Service Bulletin # 09-11

BREAKER WIRE INSPECTION

Vehicles affected: 62725 through 62790

Fig 1 View of circuit breakers

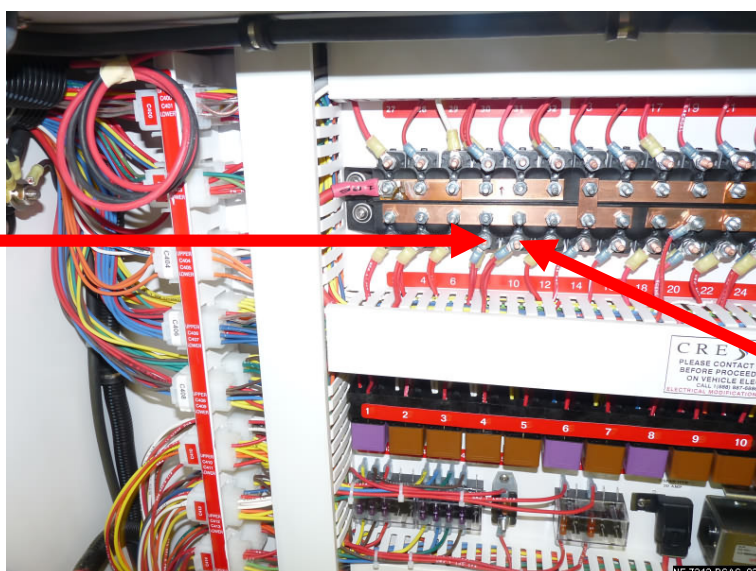
This intention of this bulletin is to confirm the correct routing of wires #58 (Thermo Power) and #154 (Right Bank Cot Lights), each located in the ecc. There have been reported incidents of the #58 wires being attached to the incorrect circuit breaker #10 which overloaded the breaker, causing it to trip. Please ensure that the #58 Thermo Power wires are attached to the #8 circuit breaker, and the #154 Right Bank Cot Light wires are attached to the #10 circuit breaker.

#8 breaker. Confirm #54 Thermo Power wires are attached here.

#10 breaker. Confirm #154 Right Cot Light wires are attached here.
